TECHNICAL BULLETIN 24.0" Headset Spacers 10/10/2017

Additional 2mm headset spacer on 24.0" models.

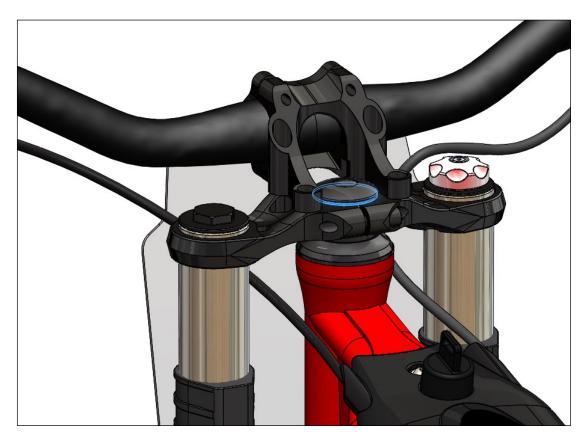
It has come to our attention that a small number of 24.0" models produced prior to 2018, may suffer from a tolerance issue which prevents the user from tightening the headset sufficiently. The cause of the issue has been identified as the headset top cap resting on the very top edge of the fork steerer tube, rather than the headset spacer as required.

The main symptom of this issue is a very slight 'knocking' noise & vibration when rocking the bike forwards & backwards with the front brake held on. If this knock is present and adjustment doesn't solve the problem, it can suggest the main headset bearing is not correctly tensioned and requires an additional spacer to be fitted.

If your bike is experiencing this issue, please contact OSET to source an additional 2mm headset spacer, which when installed beneath the headset top cap, allows the system to be tightened correctly.

Please note, bikes produced from late 2017 onwards will already have an additional 2mm headset spacer fitted to prevent this issue. In future production runs the fork steerer tube length will be modified to prevent this issue from occurring

1x CHS122736 (Headset - stem spacer, a-head, 2mm, black)
